**JNRA2022-0005  
PSP2023-0008  
Revision #3  
Received 11/29/2023**

**Site Plan Review**  
Reviewed for compliance with City Ordinance, Building and Fire Codes  
Conditions and mark-ups noted throughout plan set must be addressed prior to final approval

project  
**Oakland Gospel Halls**  
 1590 Walton Blvd.  
 Rochester Hills, MI 48309

# SITE PLAN.pdf Markup Summary

SITE SURVEY  
PART OF THE EAST 1/2 OF THE SOUTHWEST 1/4 OF SECTION 9, T.3N., R.11E., AVON TOWNSHIP (NOW CITY OF ROCHESTER HILLS), OAKLAND COUNTY, MICHIGAN

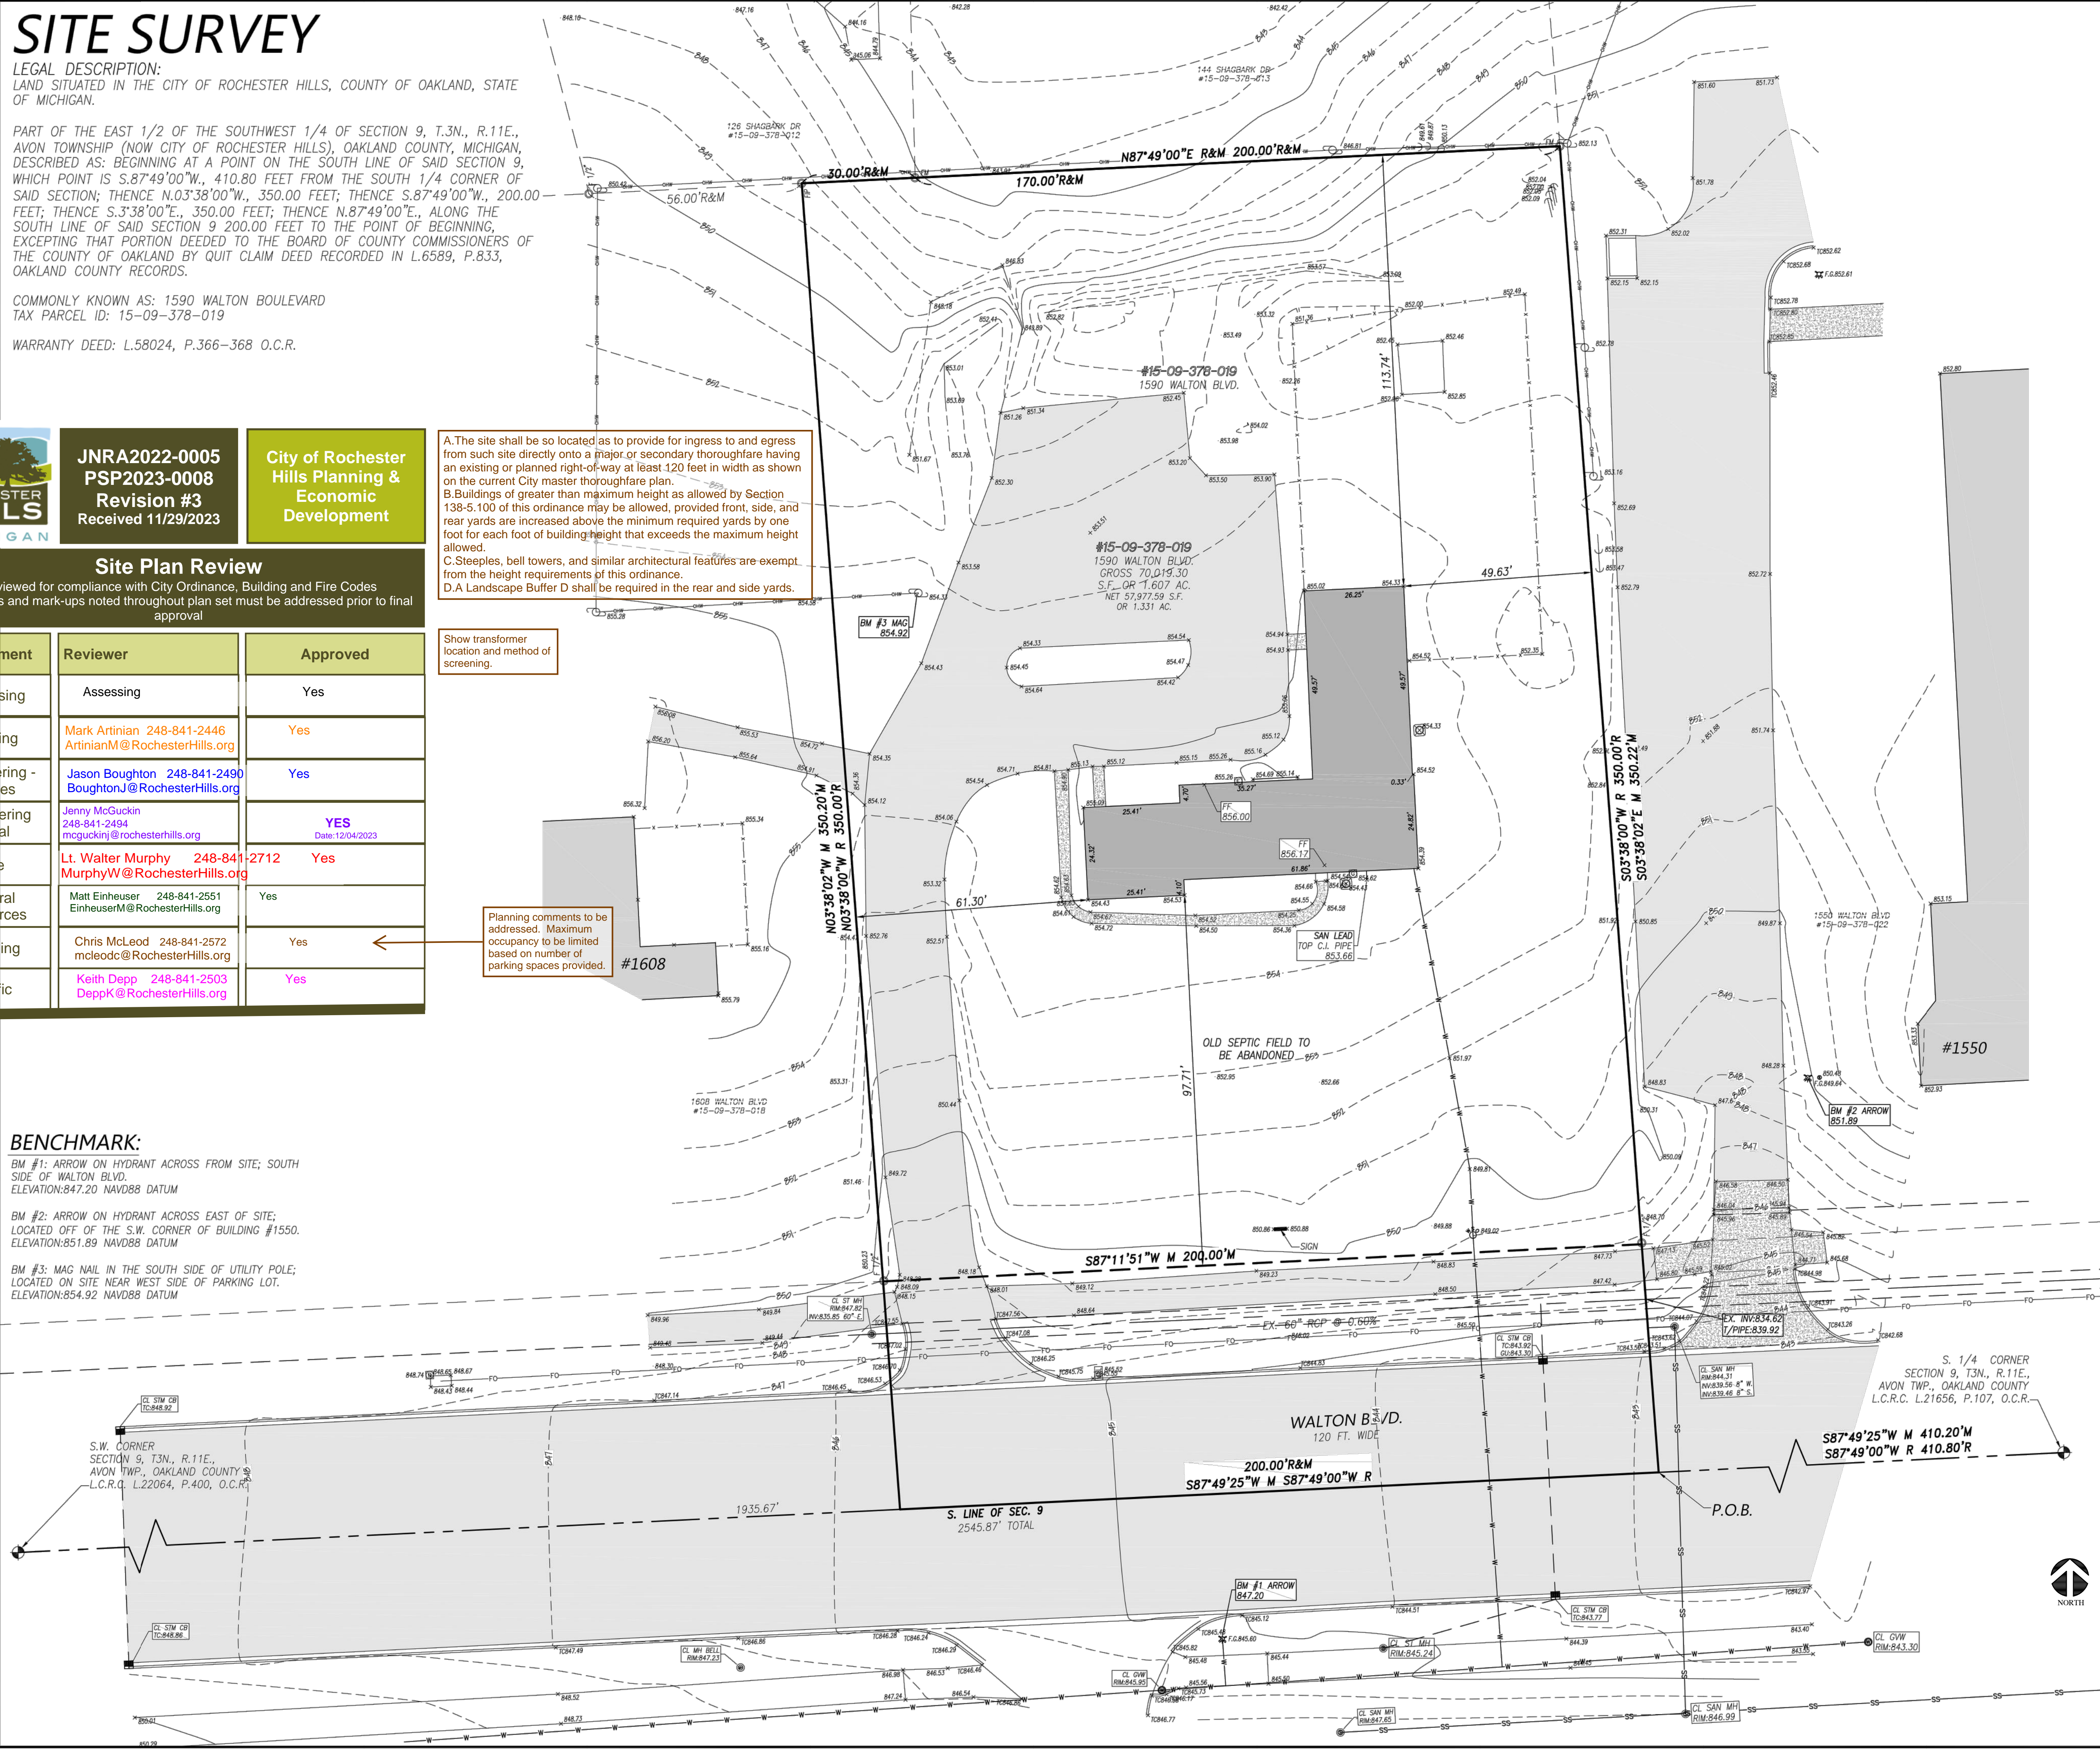
A. The site shall be so located as to provide for ingress to and egress from such site directly onto a major or secondary thoroughfare having an existing or planned right-of-way at least 120 feet in width as shown on the current City master thoroughfare plan.  
B. Buildings of greater than maximum height as allowed by Section 138-5.100 of this ordinance may be allowed, provided front, side, and rear yards are increased above the minimum required yards by one foot for each foot of building height that exceeds the maximum height allowed.  
C. Steeples, bell towers, and similar architectural features are exempt from the height requirements of this ordinance.  
D. A Landscape Buffer D shall be required in the rear and side yards.

Show transformer location and method of screening.

Planning comments to be addressed. Maximum occupancy to be limited based on number of parking spaces provided.

DEMOSITE PLAN  
 SCALE: 1" = 20'-0" (NOT OFFICIAL SURVEY)

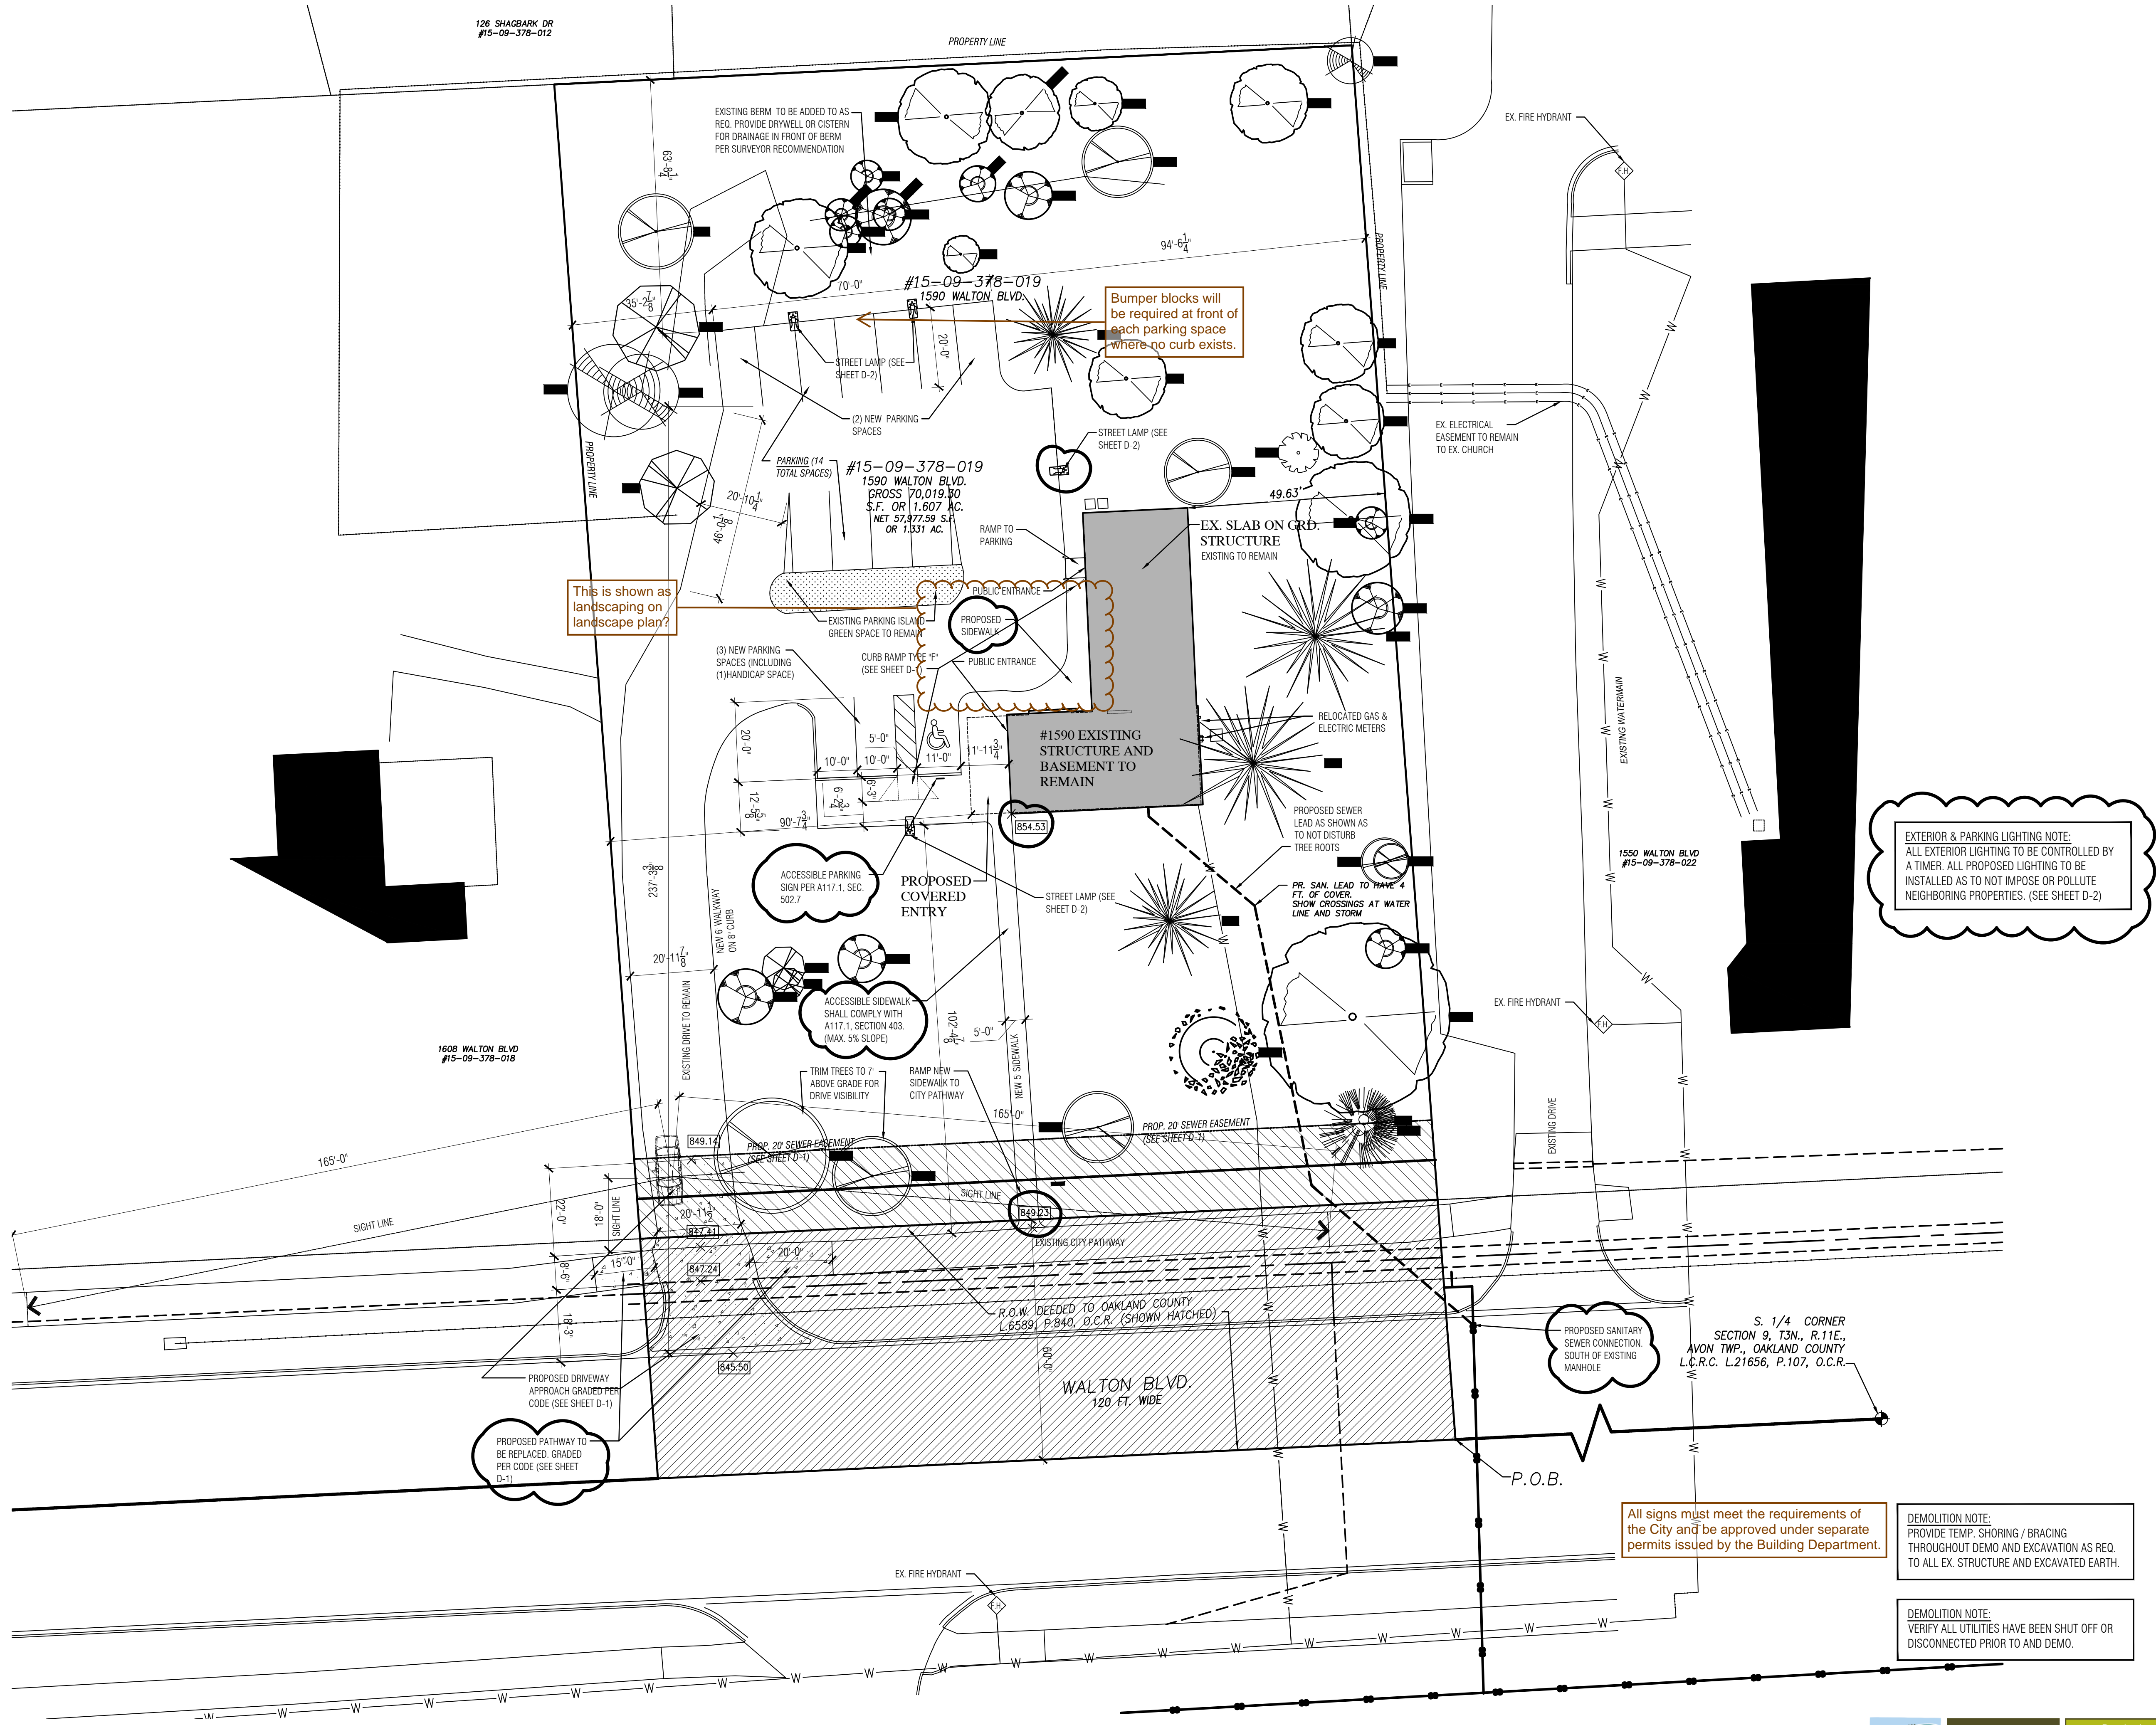
Based on a total number of 14 parking spaces, a total occupancy of 42 persons is permitted. Submitted letter indicates occupancy up to 49. Based on stated occupancy, parking is not sufficient.

All signs must meet the requirements of the City and be approved under separate permits issued by the Building Department.

**REAR (EAST) ELEVATION**  
SCALE: 1/4" = 1'-0"

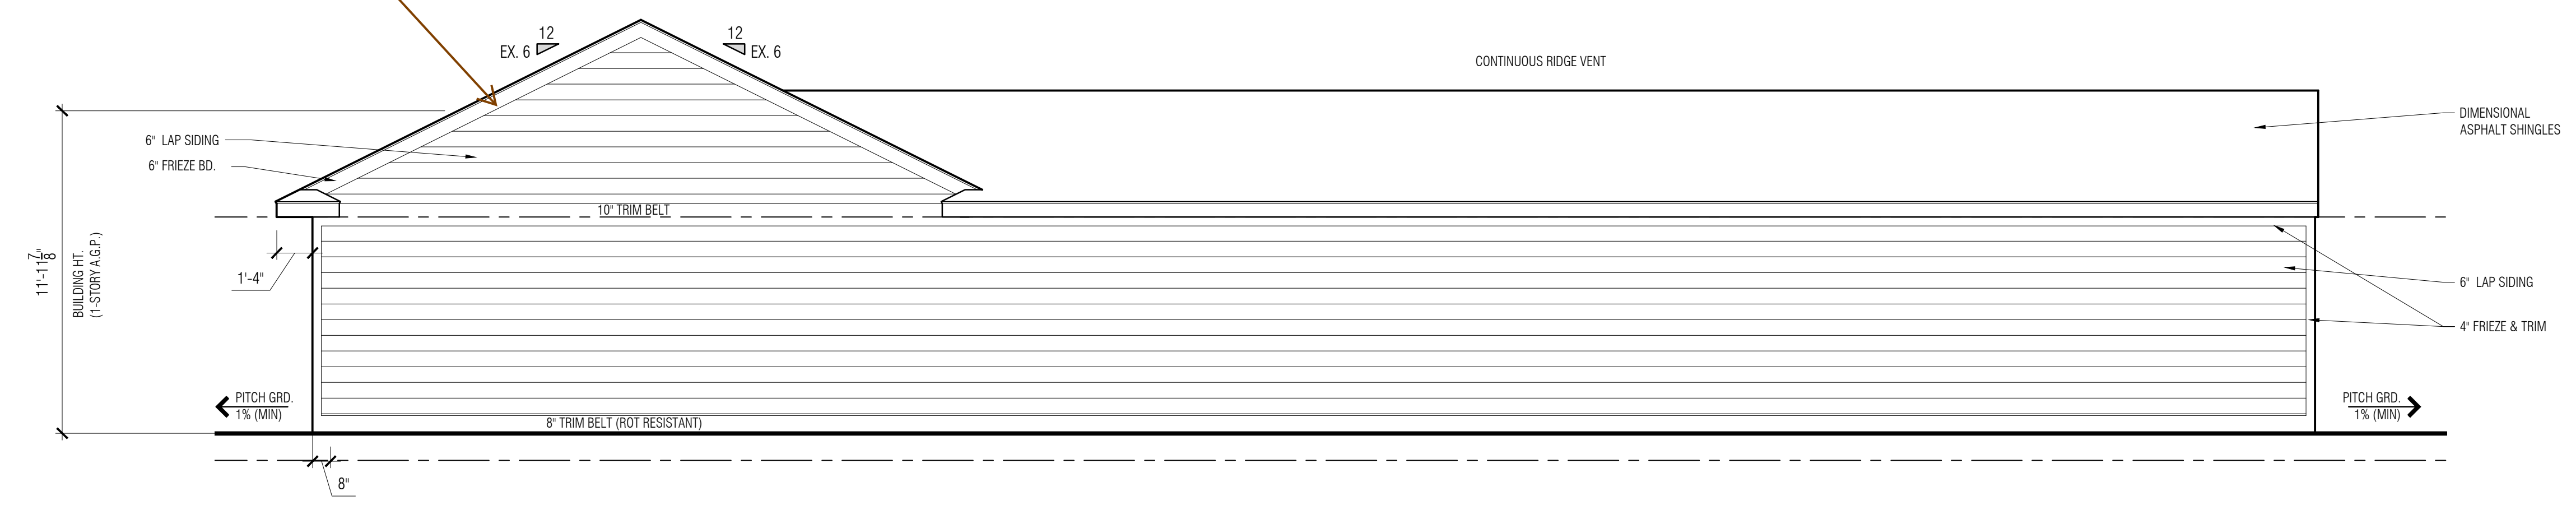
Previously shown "shake" siding should be provided in these locations.
